Re: License No. 19-00915-06
Docket No. 030-04530

Our current amendment request is to load another Model 521 Husman irradiator with a maximum of 42,000 curies of cesium-137 using an Amersham capsule X.2157.

Subject: Clarification of JL Shepherd drawing

This letter is in response to your application dated November 2, 1995, requesting safety evaluation of the Model 521 Husman irradiator with Amersham source capsules X.2157 (J.L. Shepherd Model 6810). We are in the process of evaluating your request. However, to continue our evaluation, the following information is necessary:

A-06042-4124
REV. A-1

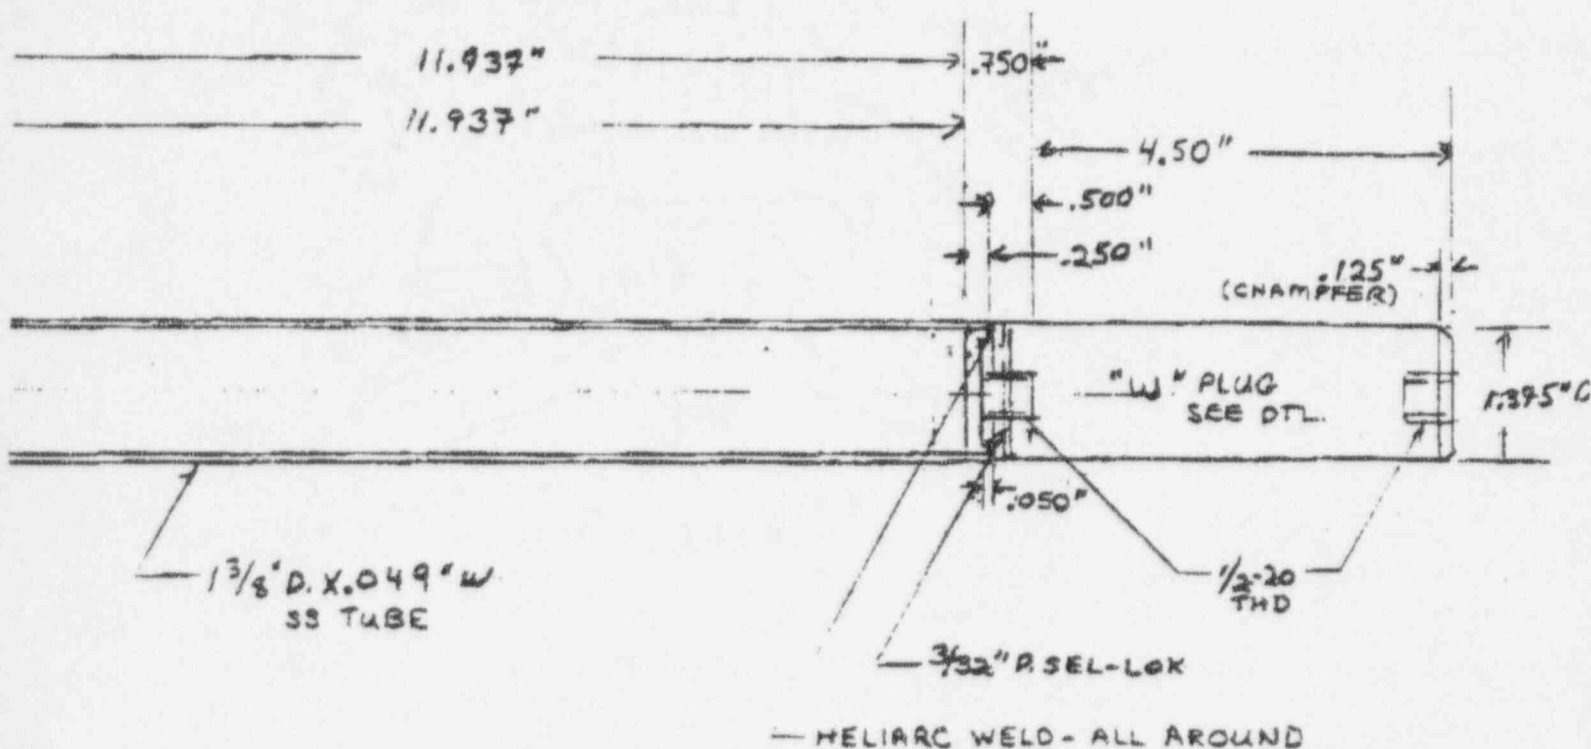
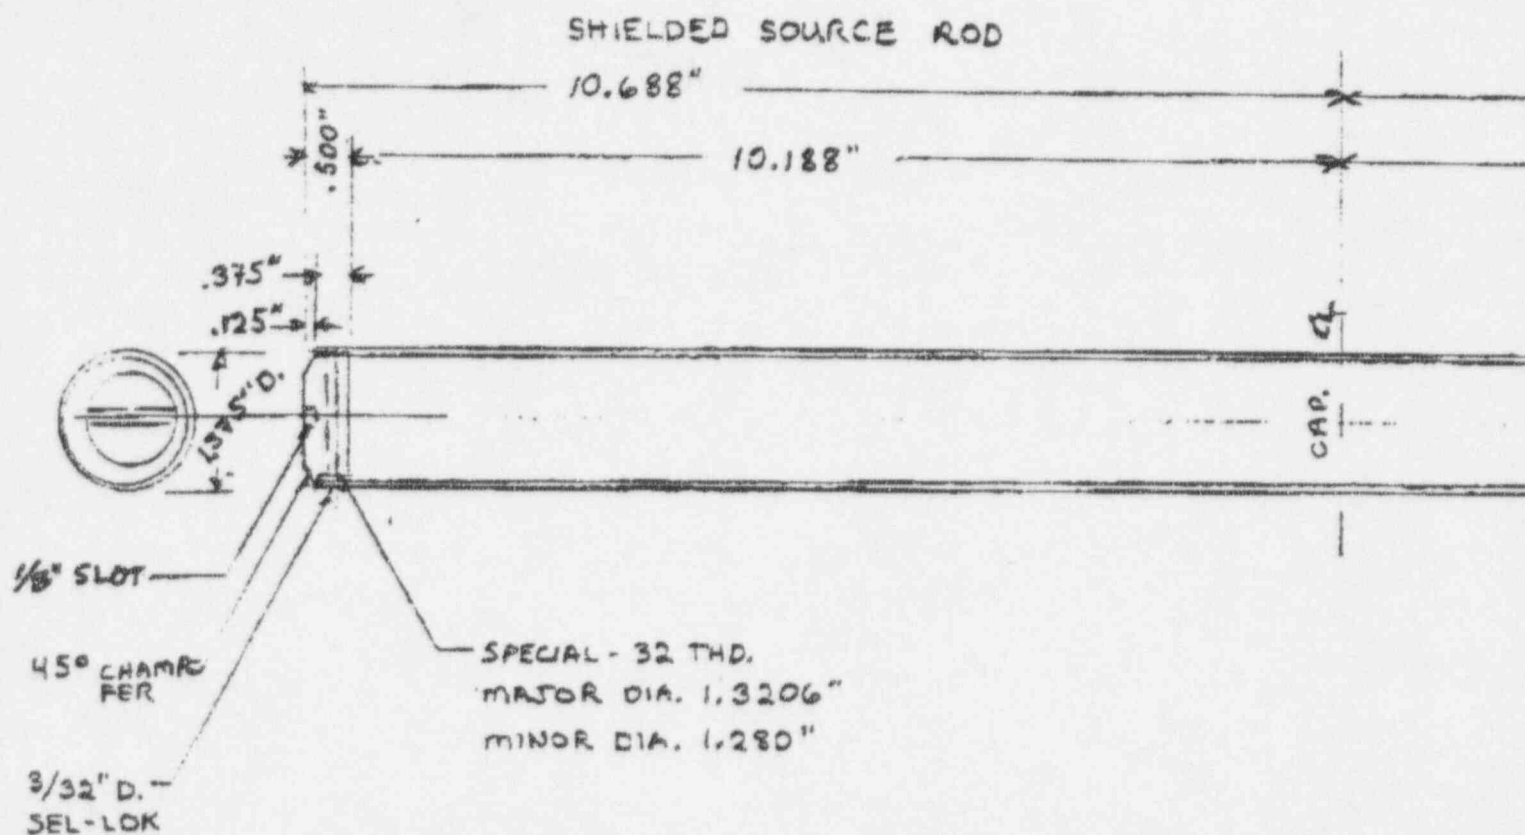
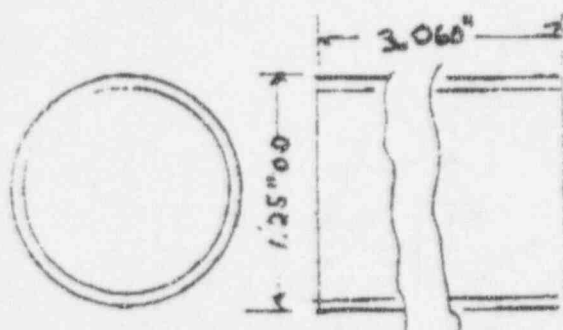
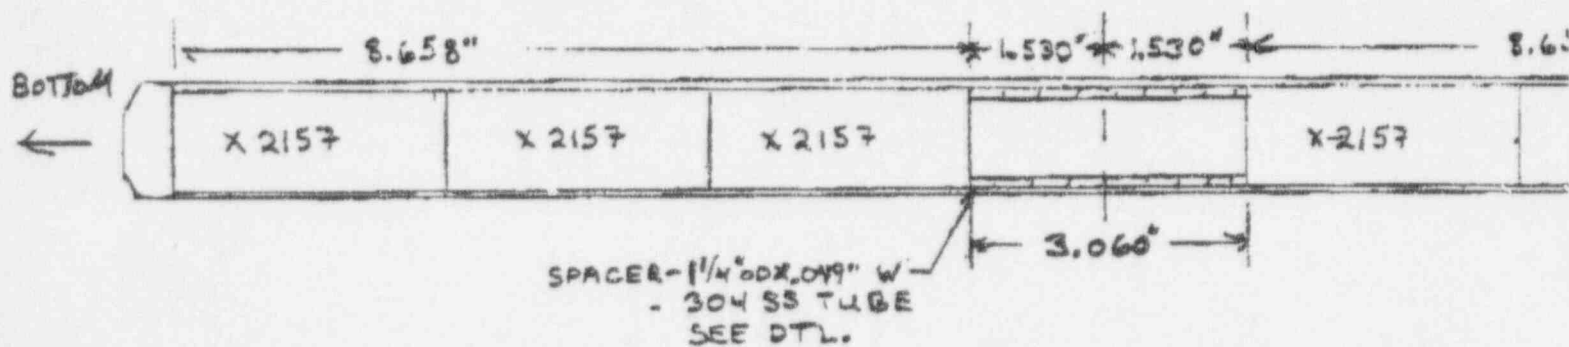
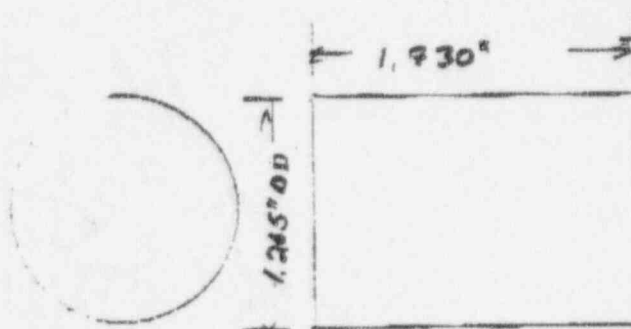
1. Please provide clear drawings concerning the Model 521 Husman irradiators and the compatibility of the requested sources with the irradiator(s). In particular, provide clearer drawings that indicate the proposed source mounting and containment within the irradiator(s) and specifications and drawings of the previously approved sources and their mounting and containment in the irradiator(s). Please also specify the materials of construction of the proposed spacers.

The first drawing is a replacement for the drawing attached to our letter to Mr. Baggett dated May 7, 1996. This drawing is more legible. It also indicates the model number of the sources (X2157) and their position in the source tube. The dimensions of these sources have been added to the drawing and are 1.265" O.D. and 2.886" long.

Drawings two and three are enlargements of the first drawing and provide greater clarity of the source tube end.
